INDESIT company

Model type:
WAS8XIT

Commercial code:
F027053

Notices

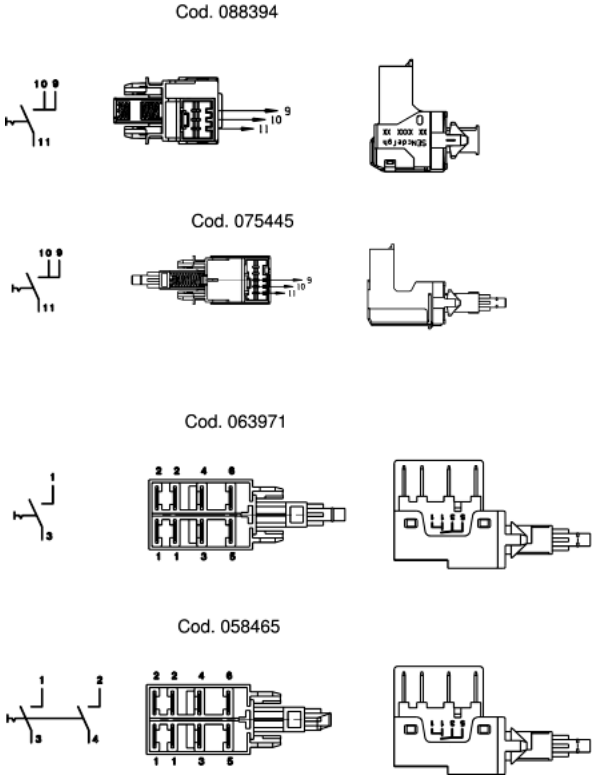
n1040276: Power supply cable + integrally moulded filter.

All appliances produced in the Comunanza (from serial no. 21008.0001), Teverola (from serial no. 21111.0001) and Brembate (from serial no. 21119.0001) factories have been equipped with power supply cables with integrally moulded filter (see fig.1 - 1A and 1B) and new units having a specific opening at the back for fixing the new cables (see fig. 1 - 1C).
The new units, together with the new cables, can be used in place of the premodification ones, by connecting the wiring to the cable, as shown in figure 1 - 1D.
The codes of the new units and of those replaced (ESI - table n1040276fig02), which will be managed until stocks run out, are given below.

The premodification wirings, are also managed for modified products by making the connection to the terminal block of the new cable as shown in fig. 1 - 1D.
The wiring diagrams given in the Documentation remain unchanged.

The new power supply cables are:
Code 091632 - Power supply cable 3x1 schuko 1.5m+capacitance filter;
Code 091633 - Power supply cable 3x1 schuko 1.5m+inductive filter;
Code 091634 - Power supply cable UK 3x1 l= 1950mm + inductive filter;
Code 091635 - Power supply cable UK 3x1 l=1950mm+capacitance filter;
Code 091636 - Power supply cable l=2.55m AUS+inductive filter;
Code 091641 - Power supply cable l=2550mm AG +capacitance filter;
Code 091642 - Power supply cable 1.85mt SHUKO no inductive filter;

IMPORTANT: the fixing / continuity screw is a specific self-scraping screw (code 092348) that ensures earth continuity between the filter and the unit. The same screw must be refitted in order to guarantee machine conformity.

FIG. 1

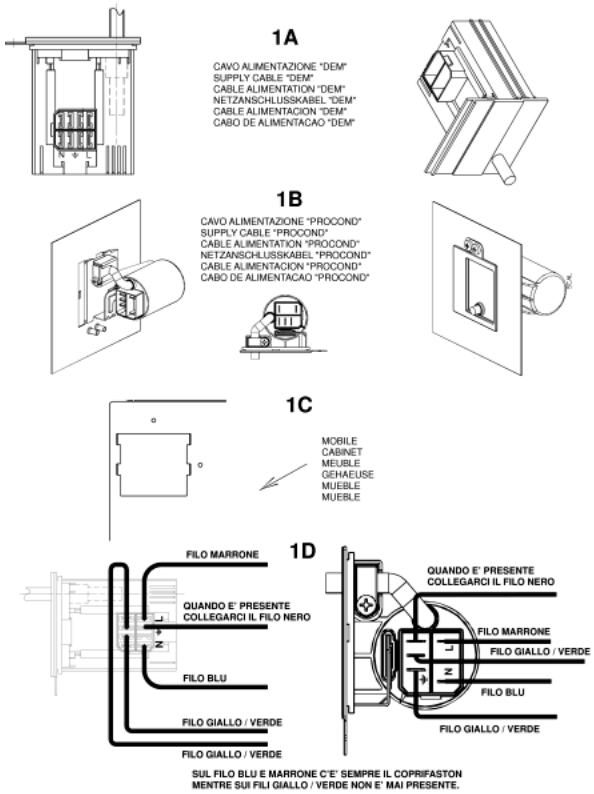
n1040282: New drainage OKO system.

From serial number 21219.0001, the new "OKO" drainage system has been introduced on the washing machines produced in the Comunanza factory.
The last two numbers of the Industrial Code (located on the rating plate) of the models relevant to this note will be 30 (e.g. 80233560130 - see Appendix A)

- EEPROM (the OKO system requires a new setting of load timing parameters). THE NEW EEPROMS REPLACE ALL THE ONES CODED PREVIOUSLY.
- BOWL (hopper tube hole shifted forwards);
- DETERGENT LOADING TUBE (see fig. 1);
- PRESSURE SWITCH (changed levels);
- OKO PUMP BOWL BLOWER + BALL (see fig. 2A, 2B and 2C);
- CONDUCTIVITY SENSOR (if provided, it is shorter than the premodification item);
- DRAIN PUMP (without detergent collecting tube connection);
- HOPPER (shifted in front of detergent loading tube connection). Fig. 3A post-modification. Fig. 3B premodification);
- AIR TRAP (different shape);
- PRESSURE SWITCH TUBE (different length);
- DRAIN TUBE STOP (specific);

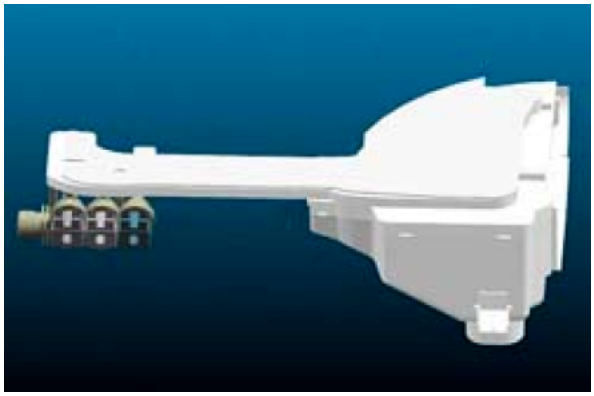
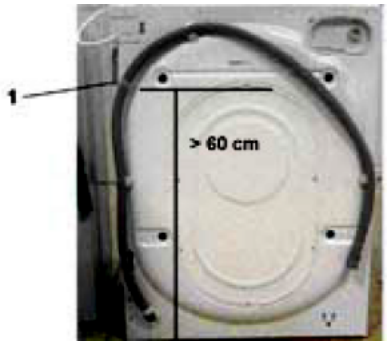
In particular, the OKO system consists of a spherical plastic component inserted in the tube that connects the bowl to the drain

pump (see fig.2 A).
At the beginning of each wash cycle the washing machine fills water for 10 seconds and activates the drain pump for 2 seconds. In this way, the water level in the bowl is different from that in the drain tube; this difference increases the thrust of the ball upwards, closing the bowl-pump connection tube hermetically (see fig. 2D).
This system has the double advantage of:

1) separating the wash water and the water in the drain hose, thus saving energy during the heating phase;
2) and ensuring optimal use of all the detergent.
With the introduction of this new component, the detergent collecting tube is no longer required and the pump has one hole only to convey water from the tank.
For the correct operation of the OKO system, it is important that the drain hose of the washing machine remains fixed to the back of the unit with a plastic clamp (to this end, the clamp withstands a 25 kg load; see reference 1 in fig. 4); otherwise, the drain hose must absolutely reach the height of the clamp. (minimum 60 cm.)

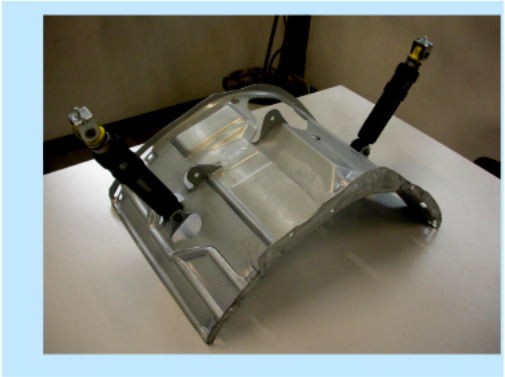
n1040325: New shock absorber fixing system with pin

From serial no. 40427.0001, shock absorbers have been fixed to the tank unit cradle with two 11 mm pins code C00110163 (see fig. 01 and 02 enclosed) in place of the 8 mm screws code 093750 and relevant locking nuts code 030443, on all washing machines and dryers produced in the Comunanza factory.
The items affected by this modification are:
1) The cradles have the same Service code, as they can be used in place of the new ones after widening the shock absorber fixing holes to a diameter of 10 mm.

To remove the shock absorber from the tank, first extract the pin with a few hammer taps (see fig.03) until it is aligned with the tank bracket and then pull it out with a pair of pliers (see fig. 04).
(To refit the shock absorber use a new pin. Insert the pin until the toroidal edge is aligned with the bracket.)

Code 093848 - Tank unit cradle 46 lt
Code 093878 - Tank unit cradle 40 lt.
2) The new shock absorbers, with fixing bushing having no s/steel spacer, are not managed as they are interchangeable with the premodified items (make sure they are CIMA type, as the managed items), fixed with M8 screws code 093750 and related locking nut code 030443 (see figs. 05 and 06).
Code 093884 - Shock absorber 80 N
Code 093885 - Shock absorber 100 N
